To: T10 Technical Committee
From: Timothy Hoglund, LSI Logic
Date: 17-January-2005
Subject: T10/05-040r0 SAS-1.1 Break_Wait handling

Figure 1

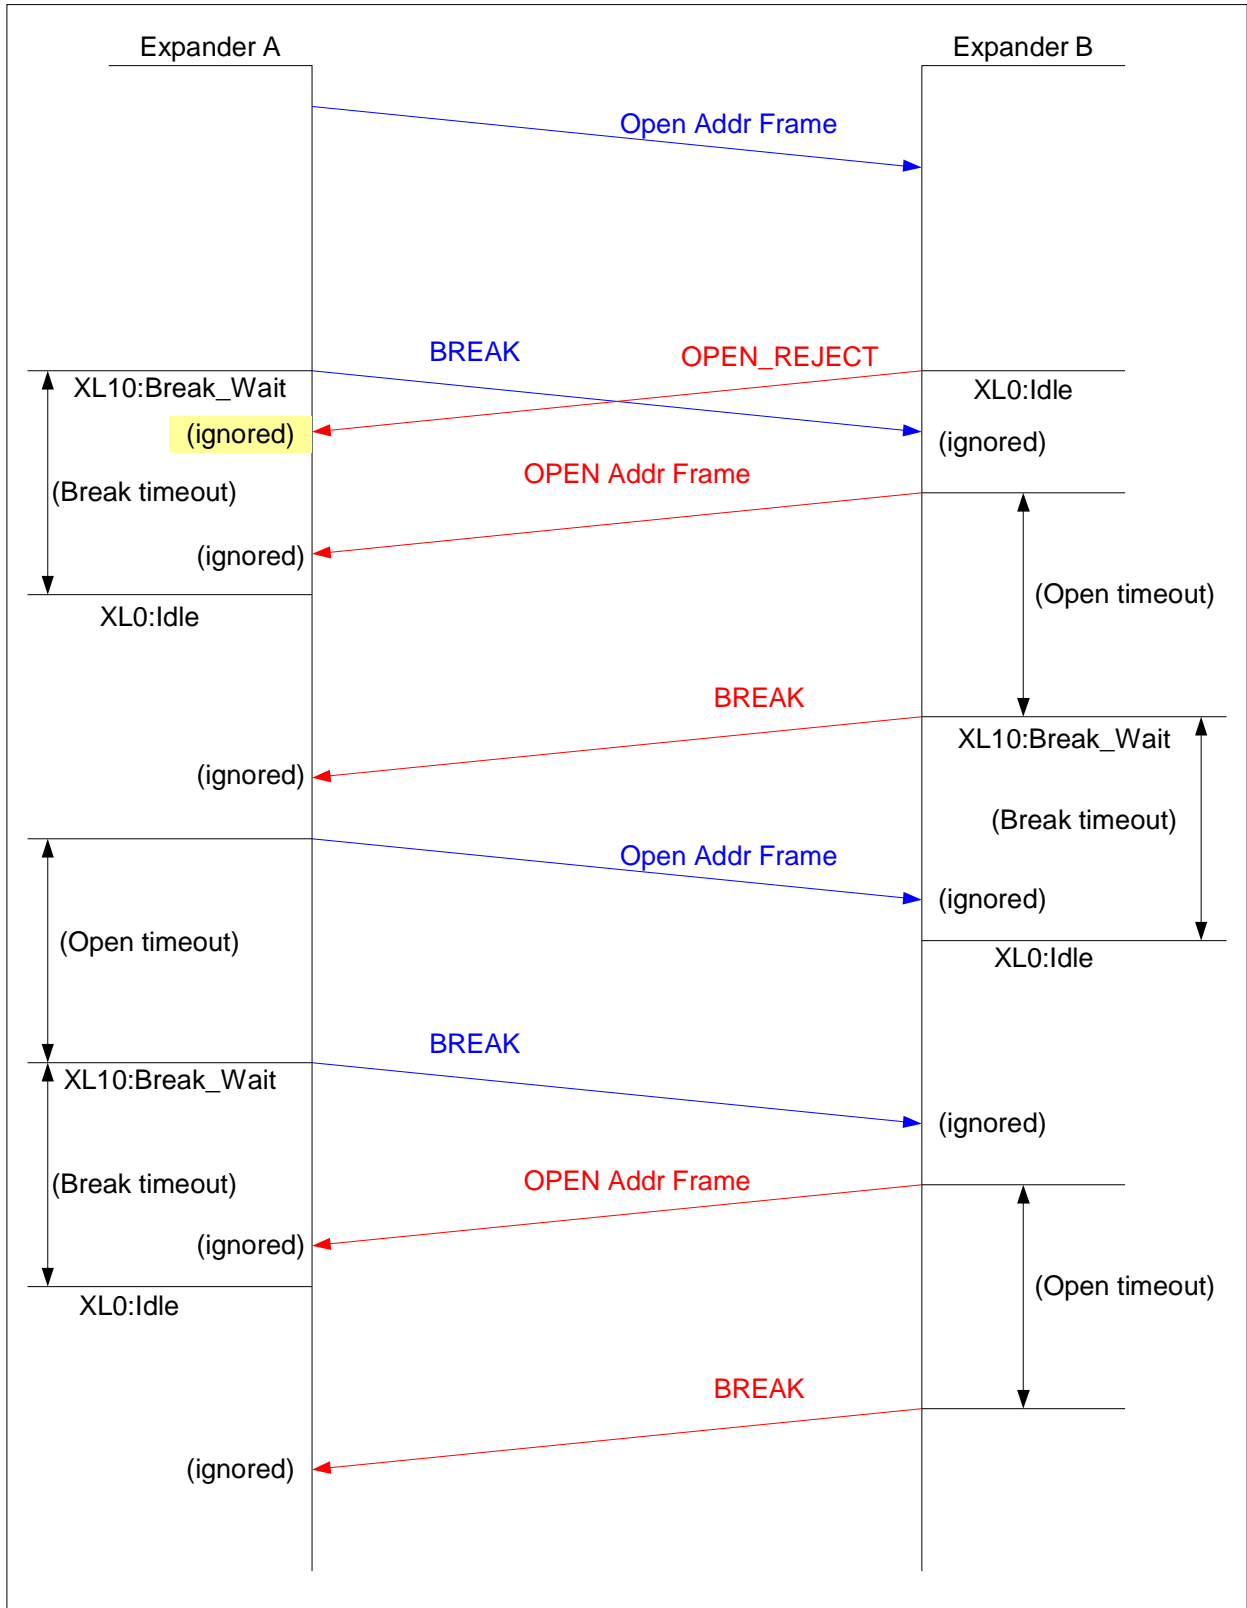
This proposal is offered to address a scenario in the XL10:Break_Wait state whereby a BREAK primitive sequence and OPEN_REJECT(n) cross on the wire. Because XL10:Break_Wait looks only at Break received and the state of its Break timeout timer, the potential exists to toggle back and forth between open timeouts and break timeouts as illustrated in Figure 1 below. Note that this situation can also happen with end devices, i.e. SL_CC5:Break_Wait state has similar problem which needs fixing.

Add OPEN_REJECT received to XL10:Break_Wait and SL_CC5:Break_Wait states as a condition to transition to XL0:Idle and SL_CC0:Idle.

This transition shall occur after:

- a) a BREAK Received message is received;
- b) the Break Timeout timer expires; or
- c) an OPEN REJECT message is received.

This transition shall occur after:

- a) a BREAK Received message is received;
- b) the Break Timeout timer expires; or
- c) an OPEN REJECT message is received.

If a BREAK Received message is not received before the Break Timeout timer expires, this state shall send a Connection Closed (Break Timeout) confirmation to the port layer before making this transition.
